Re: Permit Modification Notification Request
Hoke County LCID Landfill
LCID Permit No. 47-A

This submittal is for a modification to the Hoke County LCID Landfill. Five (5) copies of the Plans and Application, a disk containing digital copies of the Plans and Application, and the application fee are provided.

Permit Application Renewal

Hoke County LCID Landfill

LCID Deposition Sequence Detail (NTS)

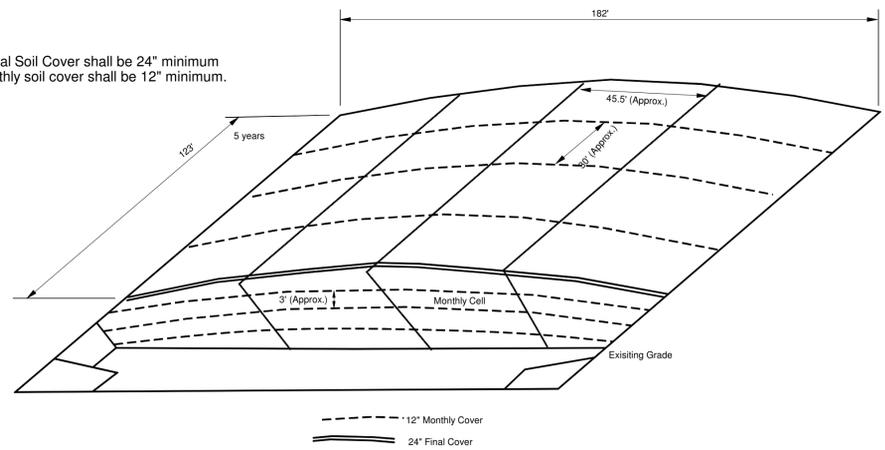
This modification also requests that slopes be 2:1 (H:V) or flatter during the excavation of the LCID cell and for the temporary cover. Final cover and slopes, however, should be 3:1 (H:V) or flatter.

Note: Excavated slopes for the cell and slope for temporary cover shall be 2:1 (H:V) or flatter. Final cover slopes along the perimeter of the waste boundary shall be 3:1 (H:V) or flatter.
